Access Compliance Report

Public Rights-of-Way

(Curb Ramps)

Intersection ID: 8908	Main Street: RUSSELL_AV	Cross Street: WELCH_PL	Location: SW
ADA ID: 604467C34D92	Ramp Type: BlendTrans2	Initial Pass/Fail: Fail	Overall Compliance: No
		Severity Score: 12.5

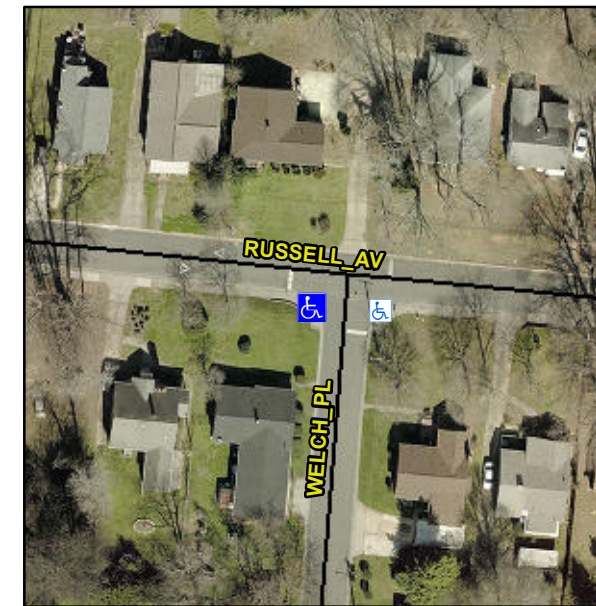
NO LT SW

Not Found, R304.5.3

Compliance	Description	Data	Compliance	Description	Data
N/A	Ramp Length (in)	59.5	Yes	BlendTrans Slope (%)	3.3
Yes	Ramp Width (in)	71.0	No	BlendTrans XSlope (%)	6.2
N/A	Flare Type LT	N/A	N/A	Flare Type RT	N/A
N/A	Flare Slope LT (%)	N/A	N/A	Flare Slope RT (%)	N/A
N/A	Flare Traversable LT?	N/A	N/A	Flare Traversable RT?	N/A
N/A	Landing Length (in)	N/A	N/A	DWS Provided?	N/A
N/A	Landing Width (in)	N/A	N/A	DWS Contrast?	N/A
N/A	Landing Slope (%)	N/A	N/A	DWS Length (in)	N/A
N/A	Landing X Slope (%)	N/A	N/A	DWS Full Width?	N/A
N/A	Landing Curb? (Y/N)	N/A	N/A	DWS Offset (in)	N/A
N/A	Shared Landing?	N/A			
N/A	Gutter Ponding?	N/A	N/A	Gutter Slope (%)	N/A
N/A	Gutter Lip Ht (in)	N/A	N/A	Gutter X Slope (%)	N/A
N/A	Painted X Walk1?	No	N/A	Painted X Walk2?	N/A
	X Walk 1 Direction	To E		X Walk 2 Direction	N/A
	X Walk 1 Width (in)	N/A		X Walk 2 Width (in)	N/A
	X Walk 1 Slope (%)	0.5		X Walk 2 Slope (%)	N/A
	X Walk 1 X Slope (%)	2.8		X Walk 2 X Slope (%)	N/A

N/A	Ramp inside XWalk1?	N/A	N/A	Ramp inside XWalk2?	N/A
	Road Slope (%)	2.8		Clear Space?	N/A
	Road X Slope (%)	0.5	N/A	Clear Space to XWalk (in)	N/A
N/A	Any Obstructions?	N/A	N/A	Storm Grate/Utility Hazard?	N/A
	Obstruction Type			Storm Grate/Utility Type	
		N/A			N/A
			Yes	Surface Condition? (G/P)	Good
			No	Curb Slope (%)	23.1

Remove & Replace Curb Ramp With Two New Directional Ramps or Equivalent.
